Tower_HRSC_CSM_GroundwaterVolumetrics.4dm -slide 1- notes in red

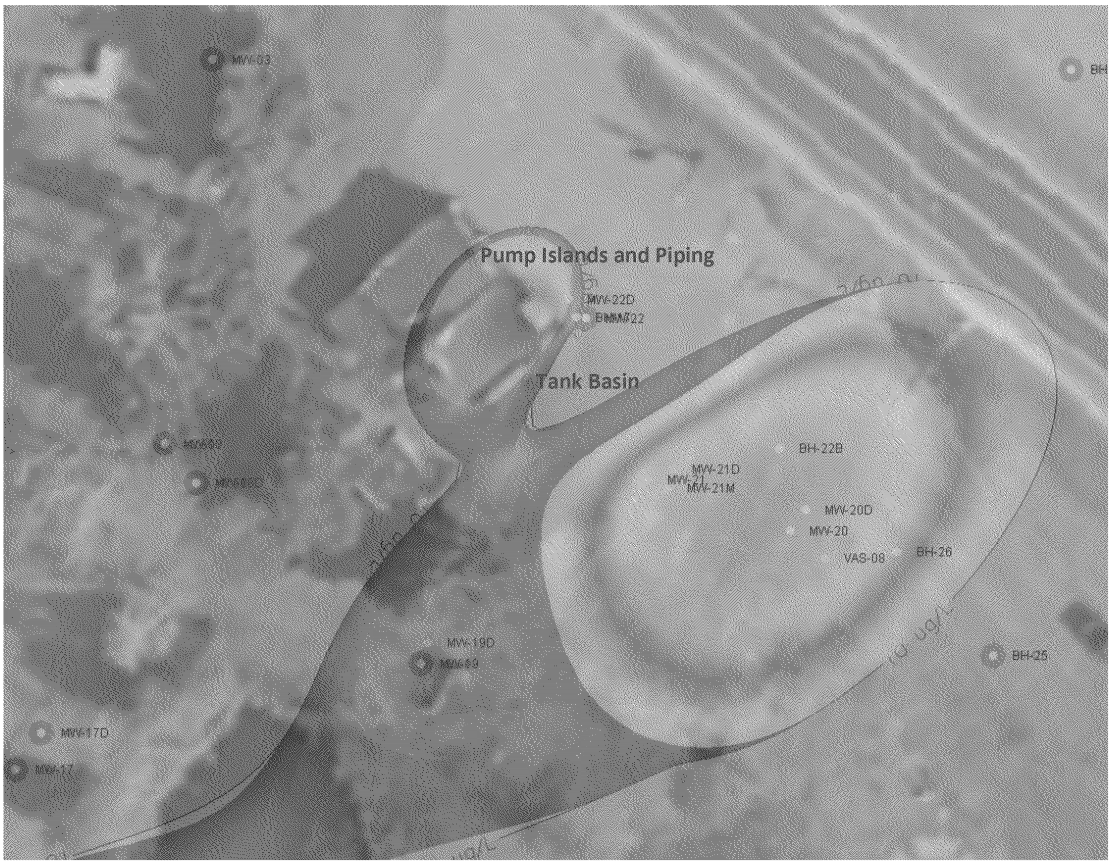
Tank Basin and Piping Excluded from Plume- Affects CSM- likely from data input errors
